Observation Report

Date:	July 17, 2017	Observation Date:	July 14, 2017
Architect:	Cannon Design	Location:	Webster ISB - General
Attn:	Kelvin Patel	Observer:	Mike Nolte (WTA)
Gen. Contr.:	Paric	M/E/P/F Contr.:	Varies
File:	Webster University Interdisciplinary Science Bldg. WT 14127.01 (7)	c:	Jason Szachnieski & Devin Gates (Paric)

Level 4 - Mechanical Observations

M0104.A - LEVEL 04 AREA A FLOOR PLAN - MECHANICAL.pdf -

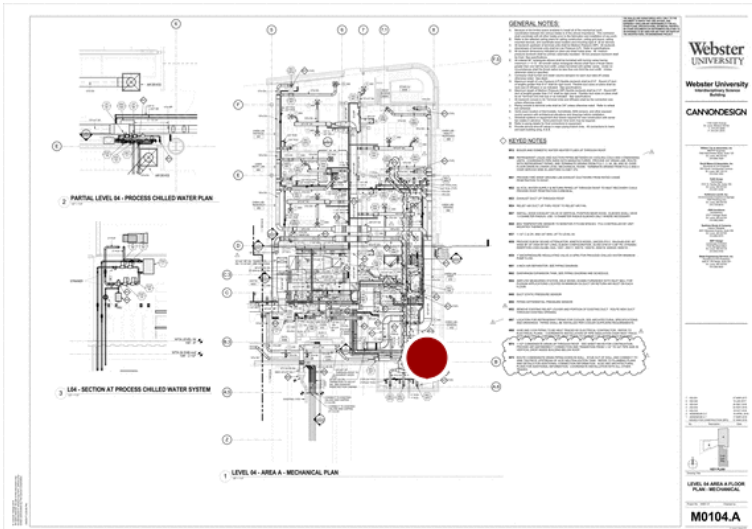
Issue ID	Description	Location Detail	Location	Status	Company	Type	Date Created	Due Date
001150	Hoods were not calibrated at time of punchlist.		Webster	Open	<not set>	Engineer Punch List	13 Jul 2017	18 Jul 2017

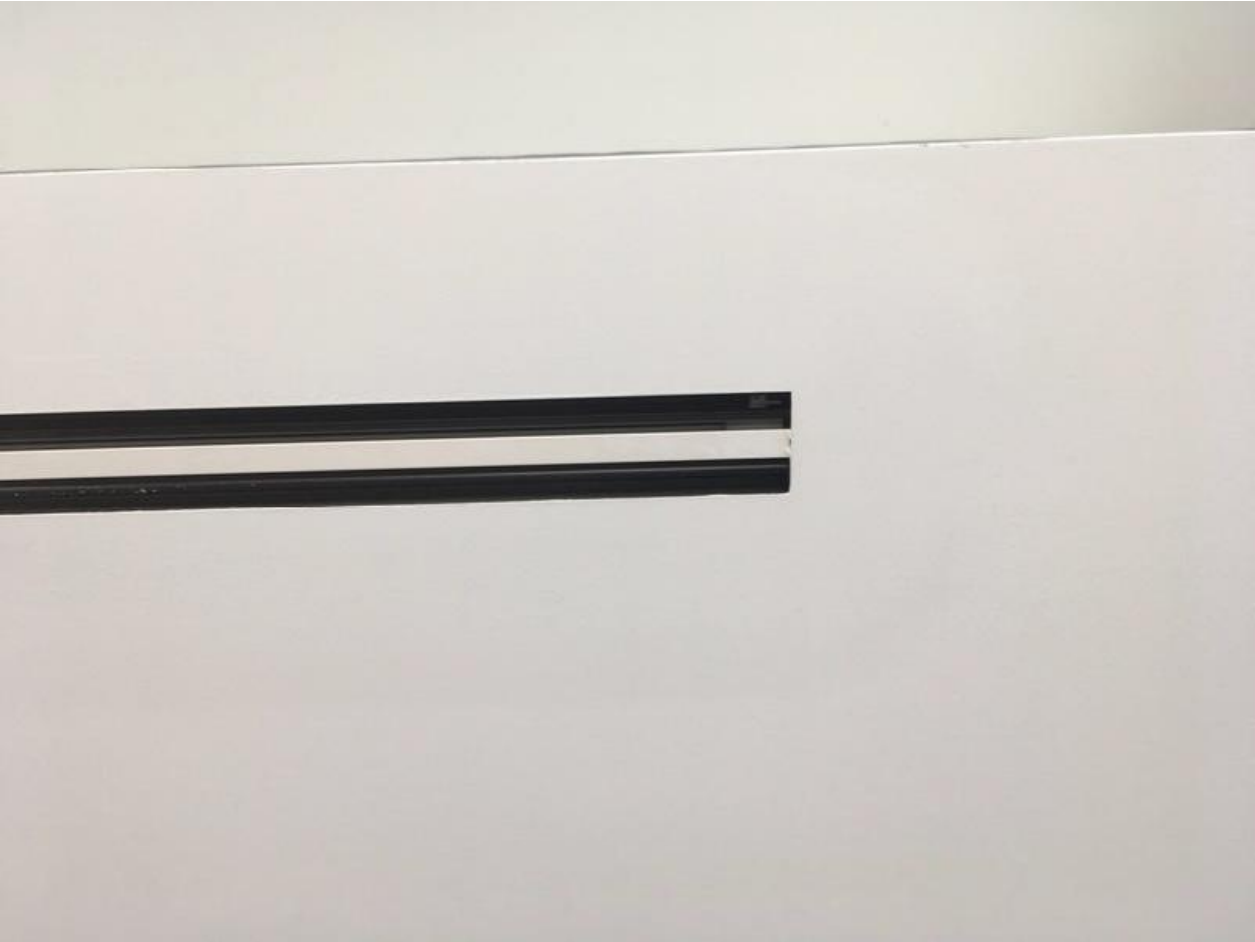
Issue ID	Description	Location Detail	Location	Status	Company	Type	Date Created	Due Date
001123	C450A: Clean up rough edges around slot diffusers touch up paint		Webster > LEVEL_04 > C450A_COMMONS	Open	William Tao & Associates, Inc.	Engineer Punch List	13 Jul 2017	18 Jul 2017
